ARCHITECTURAL REVIEW COMMISSION MEETING AGENDA

ARCHITECTURAL REVIEW COMMISSION STAFF REPORT

New Small Cell Facility – SQF, LLC

WT-21-001

Proposed Site Plan

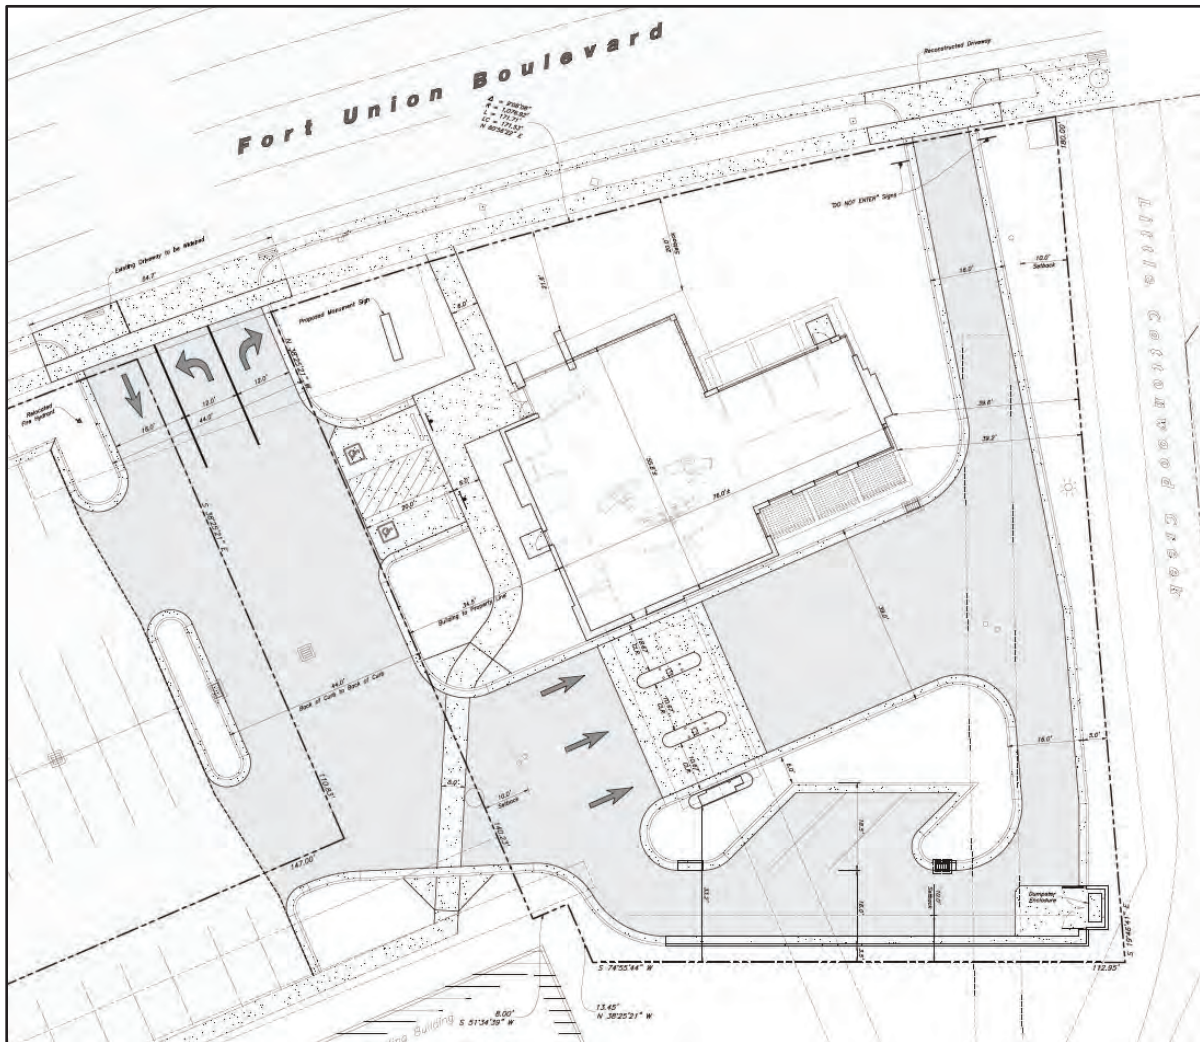
Staff Analysis: The site plan been designed to meet all setback requirements of the MU (Mixed Use) zone. A pedestrian route connecting the sidewalk to the building entrance and to the adjacent property has been proposed. Staff recommends that the sidewalk along Fort Union Blvd. be replaced with a new 6' wide sidewalk, as recommended in the City's Fort Union Area Master Plan.

Proposed Parking Plan

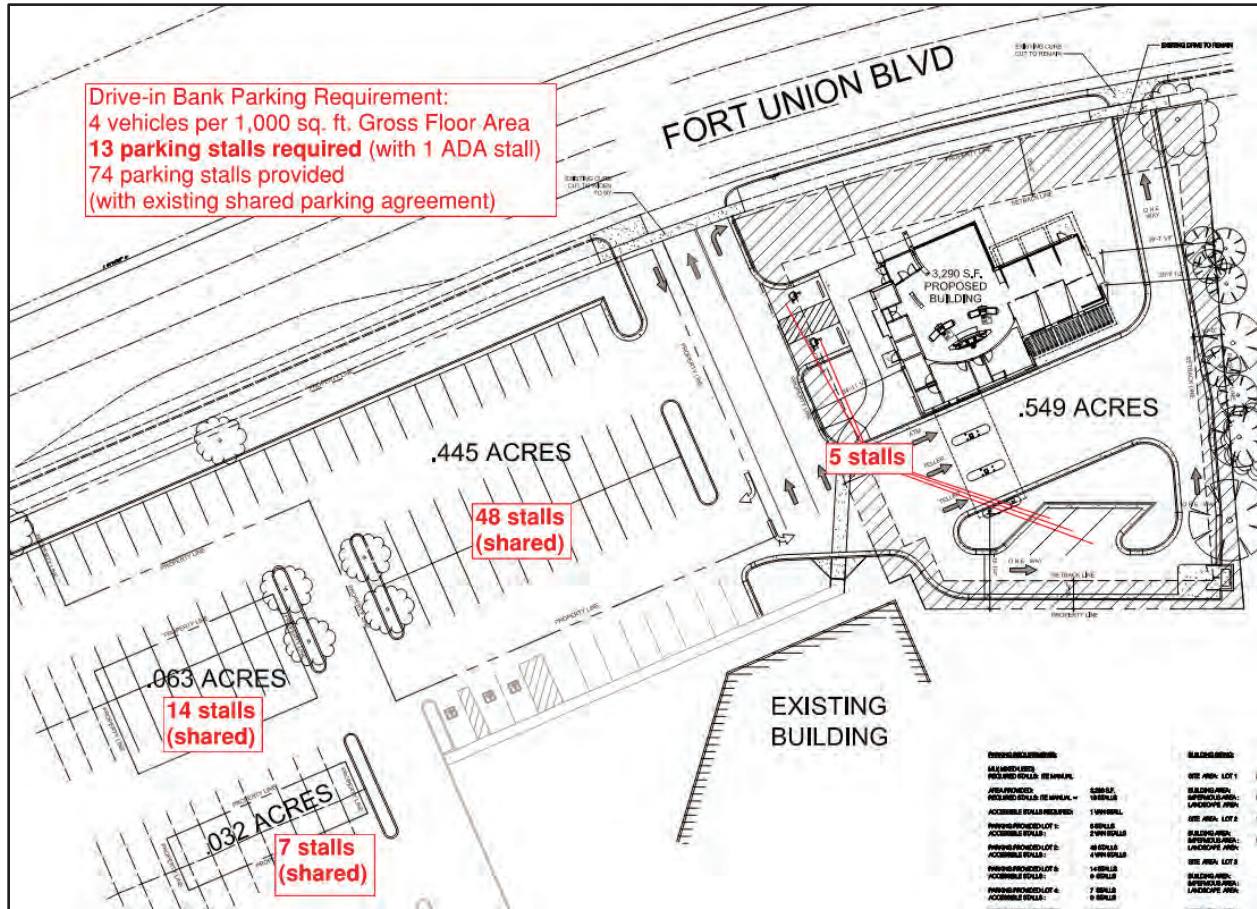
Staff Analysis: The parking plan provides more than the required number of parking stalls for a drive-in bank use. ADA parking stalls have also been moved closer to the building, providing better access to customers with disabilities.

Proposed Landscaping Plan (with markup)

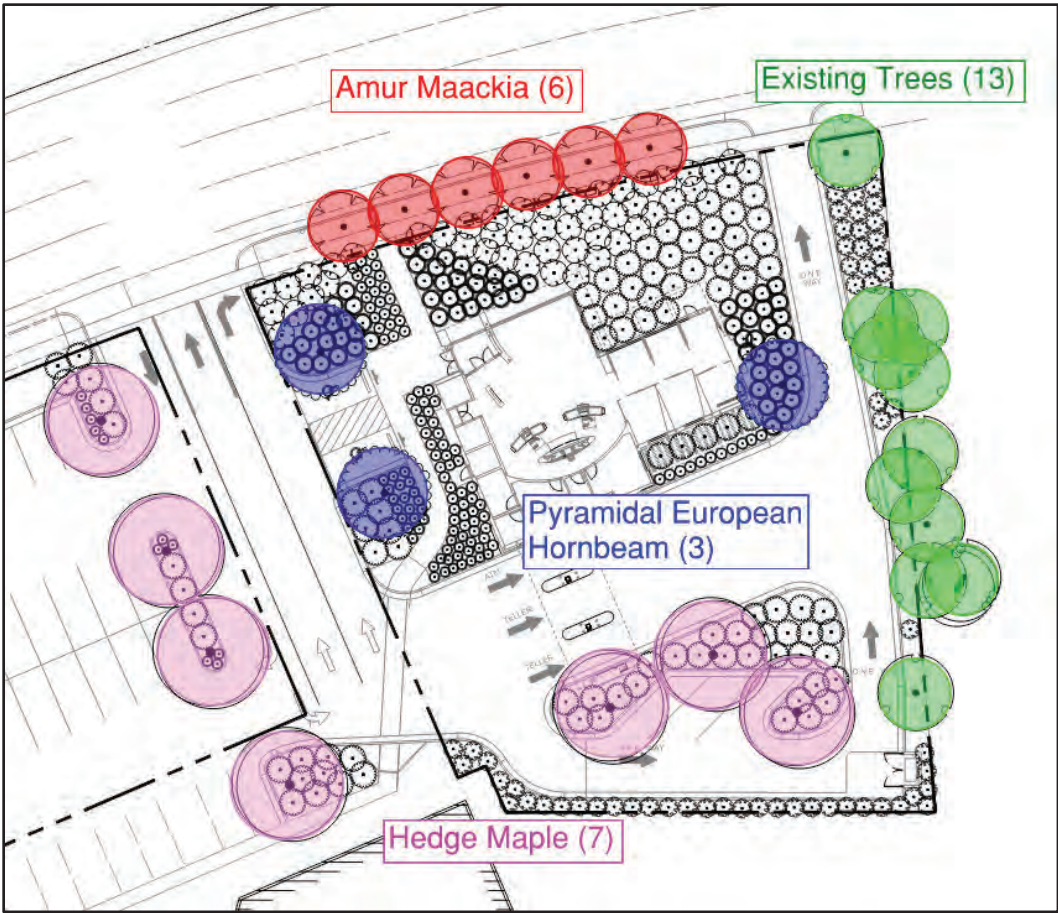
- “Use vegetation that fits in naturally with the area and the surrounding developments” (p. 17, #4)
- “Provide landscaping along and against all exterior building walls” (p. 17, #5).
- “Landscaping must be designed and use plants that are high-quality and easily maintained” (p. 18, #13).
- “Provide plans for sustainable and effective irrigation” (p. 18, #15).

Proposed Lighting Plan

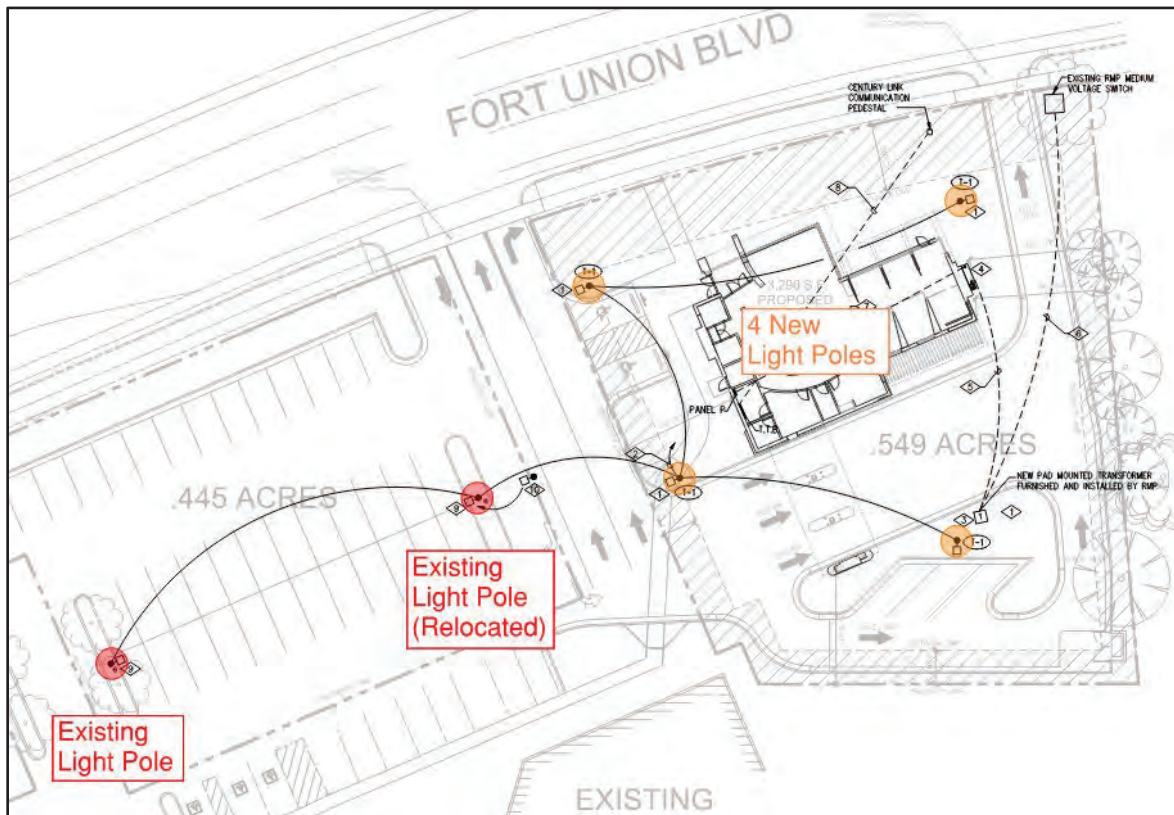
Staff Analysis: Staff recommends that the parking lot lights be reduced from 20’ to 18’ to comply with the recommendations of the Design Guidelines. Staff recommends that a streetlight be installed along Fort Union Blvd. that complies with section 12.24.190 “Street Lighting” of the City Code.
